Economic Commission for Europe**Inland Transport Committee****World Forum for Harmonization of Vehicle Regulations****174th session**

1958 Agreement:**Consideration of draft amendments****to existing UN Regulations submitted by GRB****Proposal for Supplement 3 to the 03 series of amendments
UN Regulation No. 51 (Noise of M and N categories of
vehicles)****Submitted by the Working Party on Noise***

Supplement 3 to the 03 series of amendments UN Regulation No. 51 (Noise of M and N categories of vehicles)

Figure 2: Flowchart for the check on the necessity for a silencer conditioning test

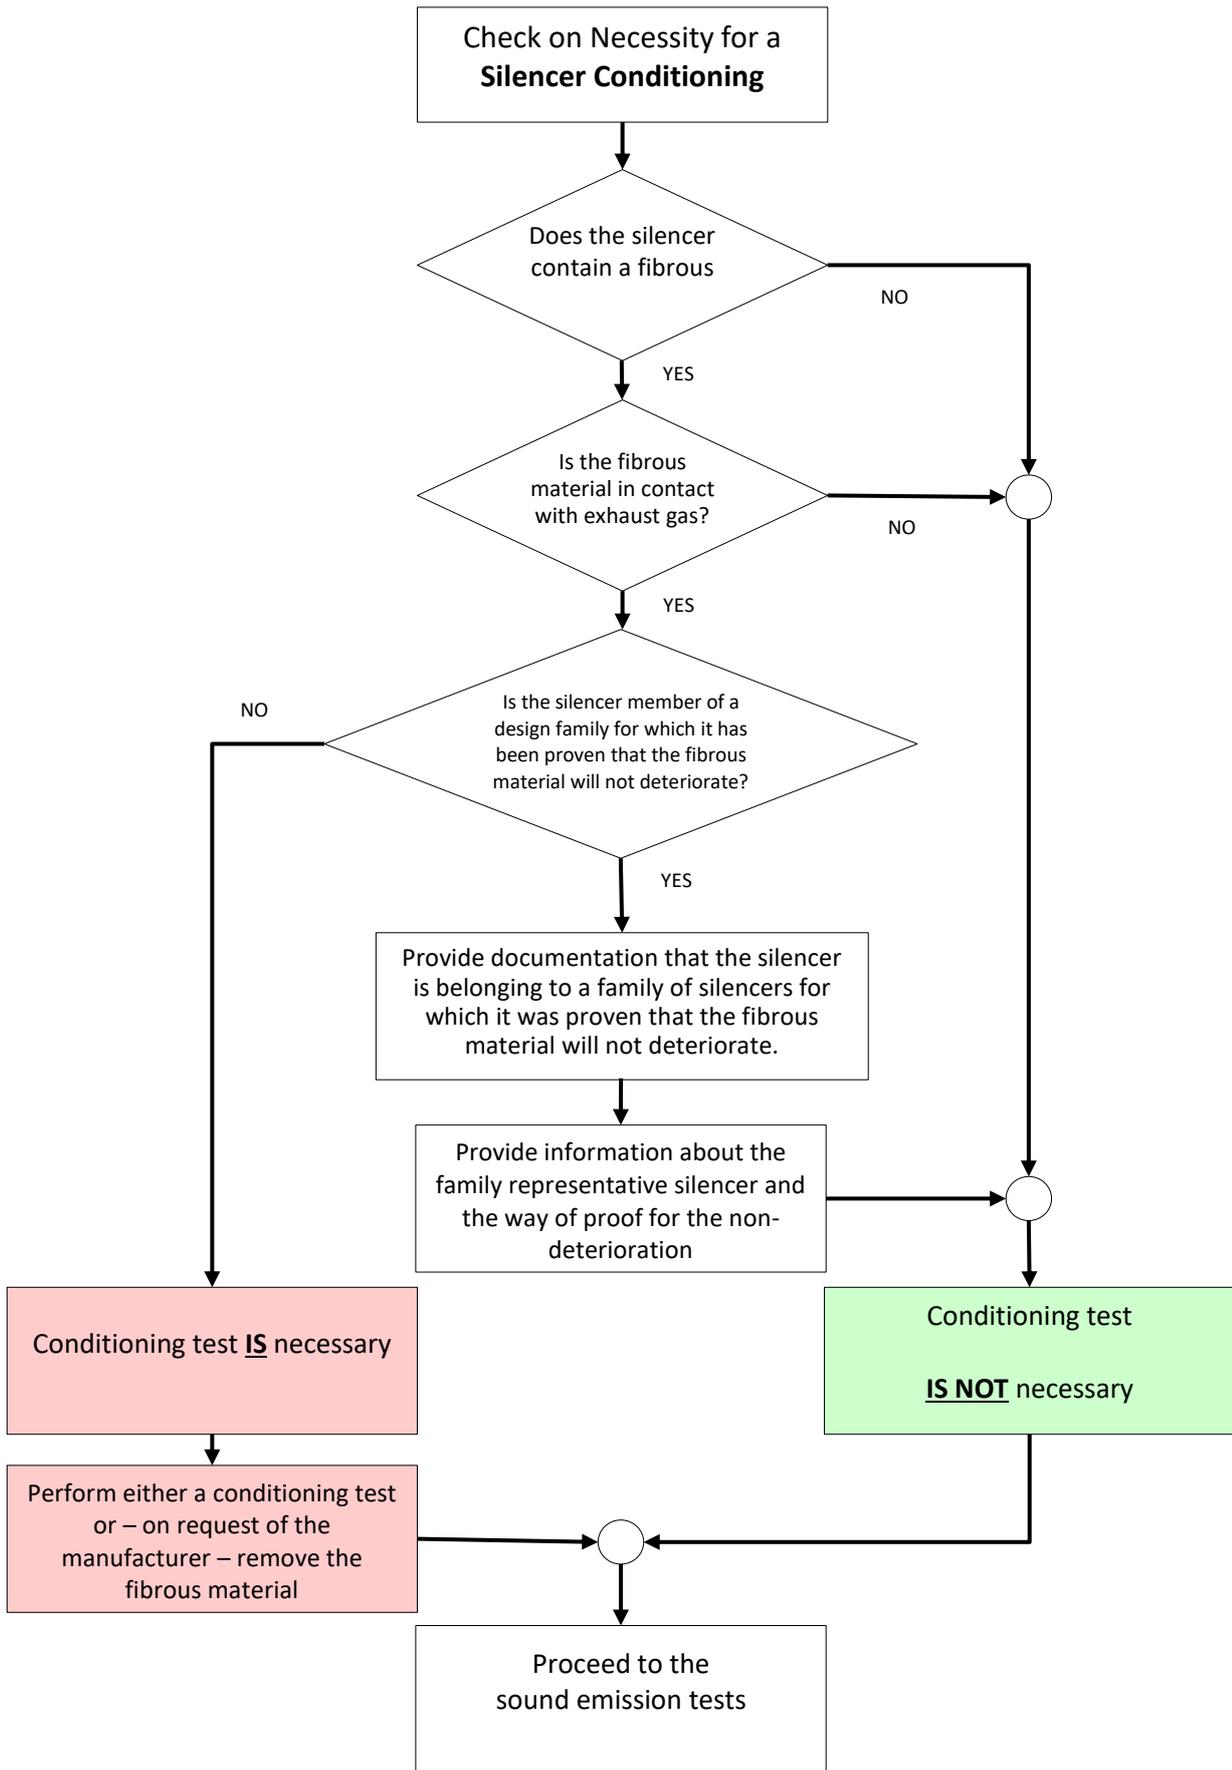
"2.2.6. If the vehicle is equipped with an exhaust system containing fibrous materials, it might be necessary to carry out a conditioning test prior to testing. The provisions of Annex 4, paragraph 1 in conjunction with the flowchart (figure 2) of the appendix to Annex 4 shall be followed."

Appendix, add a new flowchart to read:
